# Groundwater Transfer Review Summary Form

Transfer/PA # T- 14011

Application: T-14011

Applicant Name: J.R. Simplot: J.R.S. Properties III, LLP

## T-14011 - From Wells

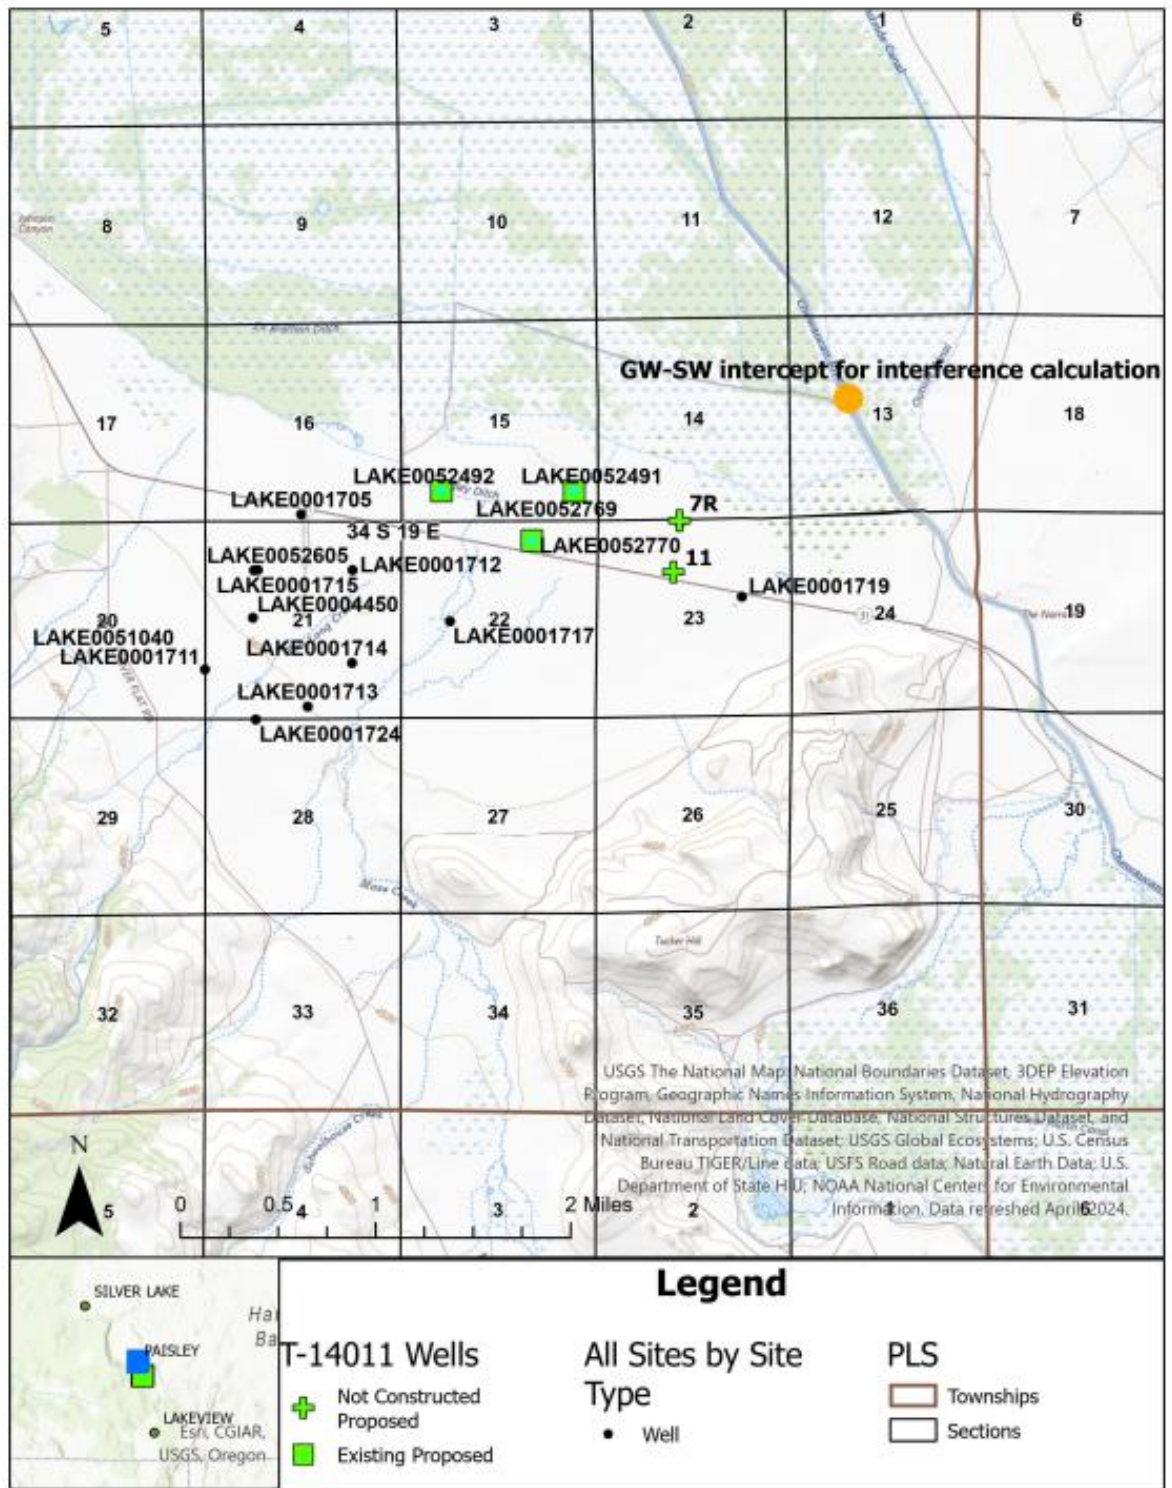
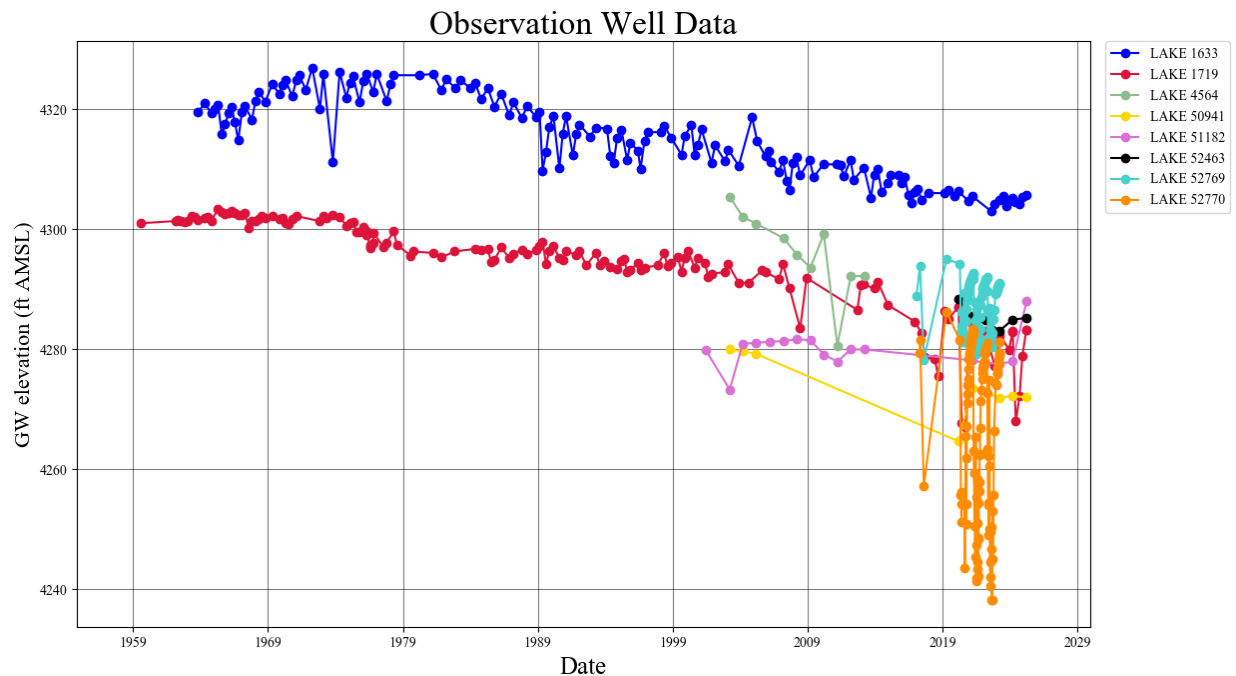
☒ Yes    ☐ No    Comments: The proposed change will move groundwater pumping about 6.8 to 8.8 mile south from the north side of Upper Chewaucan Marsh to the south side of Upper Chewaucan Marsh (see attached maps). The proposed change will move groundwater pumping closer to a different set of groundwater right wells (see attached maps).

**Additionally, the proposed change moves groundwater pumping into a vicinity that appears to be experiencing a groundwater level decline since 2005 (see attached hydrographs).** The groundwater level at well LAKE 1719 is relatively stable, near 4302 feet elevation amsl from 1960 to the mid-1970s, a decline of about 5.5 feet from the mid-1970s to early 1980s to a new equilibrium of about 4297 feet elevation amsl that is close to the Chewaucan River stage near the Narrows (relatively steady from about 1980 to 2005), and an ongoing decline since 2005, possibly taking the groundwater level below the river bottom. The groundwater level decline in the 1970s and after 2010 may correspond to increased groundwater development in the area.

The applicant has submitted 2017 to 2023 data (see hydrographs) for wells LAKE 52769 [60 feet total depth], and LAKE 52770 [1,100 feet total depth], and LAKE 52463 [410 feet total depth]. The data can be interpreted as showing an annual decline similar to LAKE 1719.
